SERVICE BULLETIN #14

Subject: Hale CBP Booster Pump

SK-145

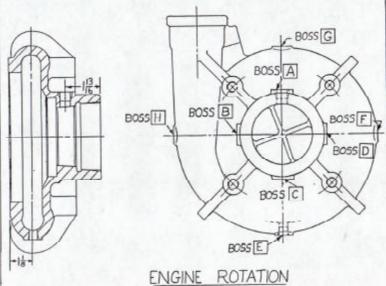
The Hale Service Department has examined a number of CBP installations with improperly located priming connections.

We have found that nine out of ten service calls concerning slow priming or inability to prime are due to an improperly located priming connection.

If, after the pump has been drilled, you find it necessary to change the discharge position, you should relocate both your priming and your drain taps. The attached sketch, SK145, gives the locations for both of these taps.

The enclosed Plate #SK145 shows the proper priming location for the various CBP Pump discharge positions.

We do offer to drill the proper location for priming and draining the pump for any of the various positions available. However, you will have to state the position required when ordering your CBP pump.
